**CERTIFICATE OF COMPLIANCE
FOR RADIOACTIVE MATERIAL PACKAGES**

1 a. CERTIFICATE NUMBER	b. REVISION NUMBER	c. DOCKET NUMBER	d. PACKAGE IDENTIFICATION NUMBER	PAGE	PAGES
9235	12	71-9235	USA/9235/B(U)F-96	1 OF	15

By letter dated December 17, 2009, as supplemented February 3, April 28, June 3, August 19, and September 1, 2010, NAC International (NAC) submitted a revised application in accordance with 10 CFR Part 71 for an amendment to Certificate of Compliance (CoC) No. 9235 for the Model No. NAC-STC package to incorporate the Dairyland Power Cooperative's LaCrosse boiling water reactor (LACBWR) fuel as authorized contents.

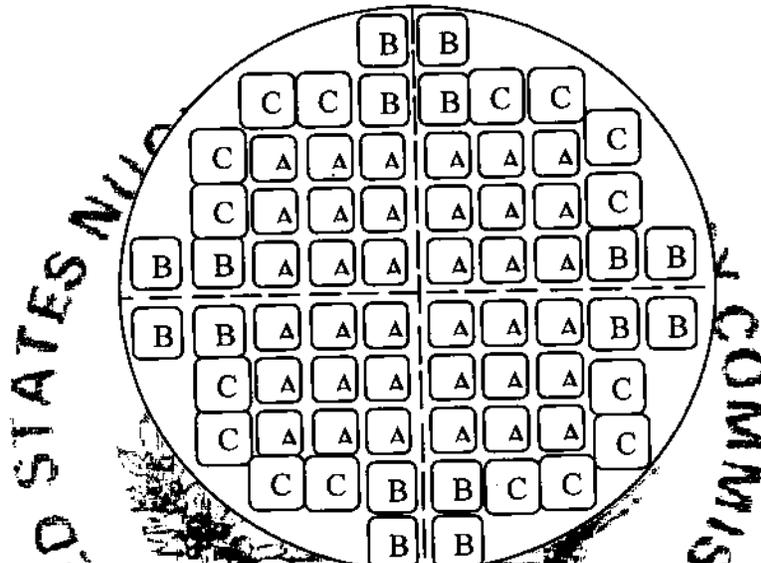
The staff used the fuel loading pattern as described in Figure 6.8.1-1 of the NAC-STC SAR. In Slot A the staff assumed undamaged Exxon Fuel assemblies. In Slot B the staff assumed damaged Allis Chalmers Fuel assemblies with an enrichment of 3.64%. In Slot C, the staff assumed damaged Allis Chalmers fuel assemblies with an enrichment of 3.94%.

Slot A: Undamaged Exxon fuel maximum planar average enrichment 3.71 wt% ²³⁵U.

Slot B: Undamaged or damaged Exxon fuel maximum planar average enrichment 3.71 wt% ²³⁵U, up to four slots maximum, B and C combined. Damaged Allis Chalmers fuel maximum enrichment 3.64 wt% ²³⁵U.

Slot C: Undamaged or damaged Exxon fuel maximum planar average enrichment 3.71 wt% ²³⁵U, up to four slots maximum, B and C combined. Damaged Allis Chalmers fuel maximum enrichment 3.94 wt% ²³⁵U.
